REGIONAL REVIEW NOTIFICATION

ARC REVIEW CODE: R2104141

Name of Proposal: 300 Marketplace DRI #3252

SITE PLAN - DRI NO. 3252 300 MARKETPLACE

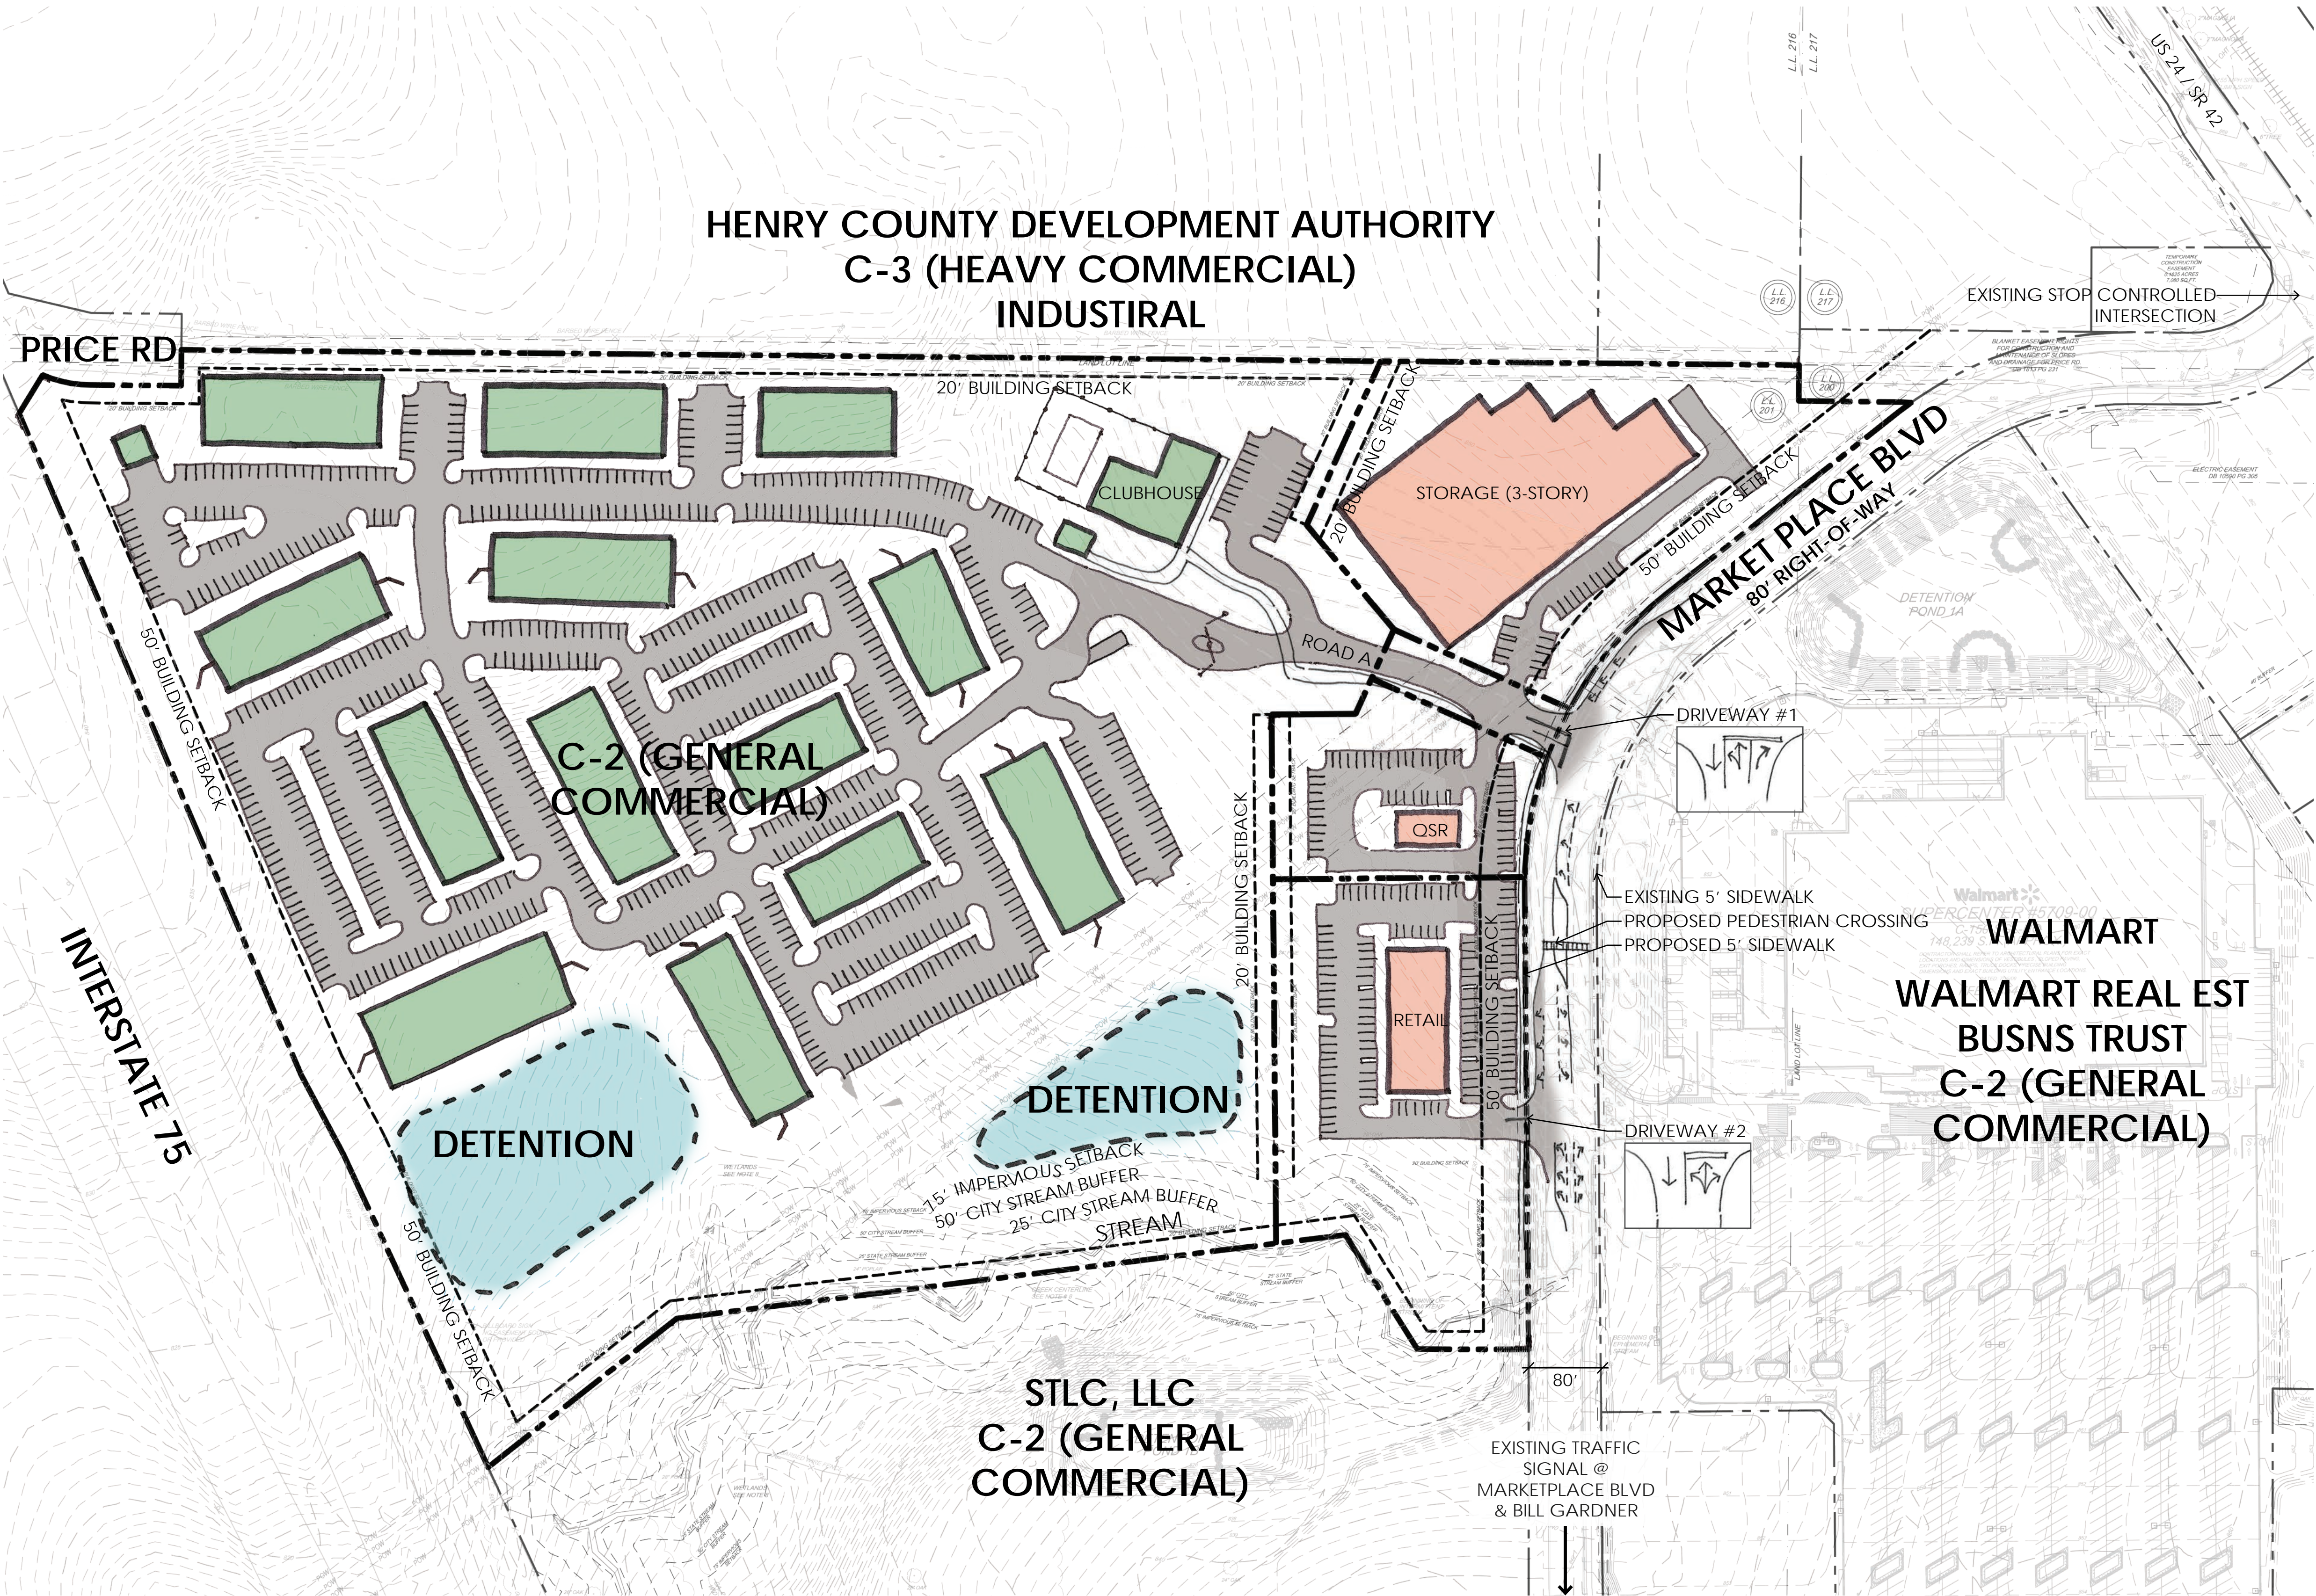
- The retail and quick-serve restaurant (likely with drive-through service) are surrounded by surface parking. Pedestrians living inside the development will need to cross the driveway entrance for this restaurant to reach Market Place Boulevard. This could lead to numerous and constant conflicts, depending on the popularity of the tenant.

- The DRI will build sidewalks on its frontage on Market Place Boulevard, but there are no other sidewalks on the remainder of the western side of the street between Bill Gardner and SR 42.

- A pedestrian crossing is needed in the vicinity of the DRI to allow residents to safely cross Market Place Boulevard to reach the sidewalk on the eastern side, as well as the Walmart and other businesses. Based on discussion at the pre-review/methodology meeting and as detailed in the traffic study, the applicant proposes coordinating with the City and County to locate an enhanced pedestrian facility at or around mid-block between driveways 1 and 2 of the DRI. Design guidance and other considerations are available at <https://atlantaregional.org/transportation-mobility/bike-ped/bicycle-pedestrian/>.

- The submitted site plan does not show pedestrian facilities and connections among uses within the site. These will likely be required under standard GRTA conditions.

The USGS coverage for the project area shows a blue line stream running from the pond across Price Road from the project across the property to its western edge. This stream is not shown on the submitted site plan and the e submitted site plan does not show this stream, which appears to run through the General Commercial portion of the project. However, the site plan shows an unmapped stream along the southern edge of the property with the city's 50-foot buffer and 75-foot impervious setback shown as well as the 25-foot State Erosion and Sedimentation Act buffer. No intrusions into those buffers is shown.

Currently, there is only a 5' sidewalk on the eastern side of Market Place Blvd. The traffic report did not clearly define pedestrian and bicycle accommodations within the development; however, it is proposed to improve the pedestrian crossing on Market Place Blvd.

The proposer should clarify pedestrian and bicycle accommodations within the development and clarify the connection with the proposed Market Place Blvd. crossing.
